## Subject: Design-Build of Embellishment Works along the Metro Corridor from Rose Hill to Port Louis.

Procurement Ref No: MEL/METRO/EMBRP/09/2021

## Addendum No 1

Table 2: Planned infrastructure by MEL's advertising partner

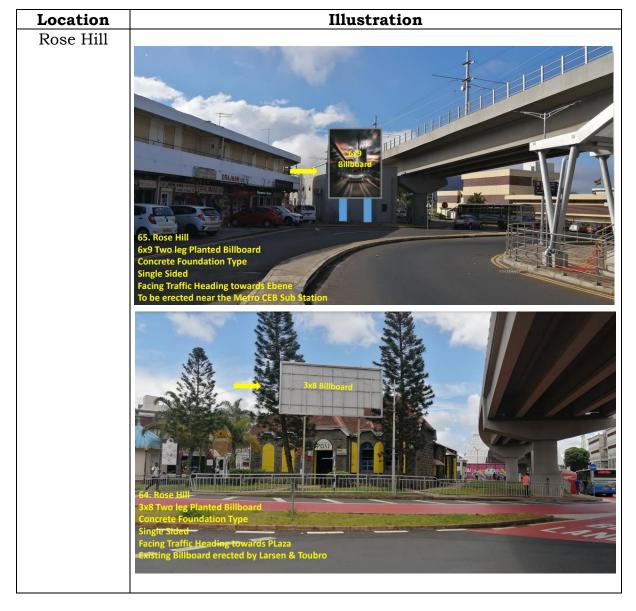
The following has been added as a requirement under the heading **Commercial Spaces**:

d) Have an integrated design between the embellishment project and the existing/future advertising infrastructures planned by the advertising partner of MEL.

The future advertising infrastructures along the corridor (excluding stations) are as follows:
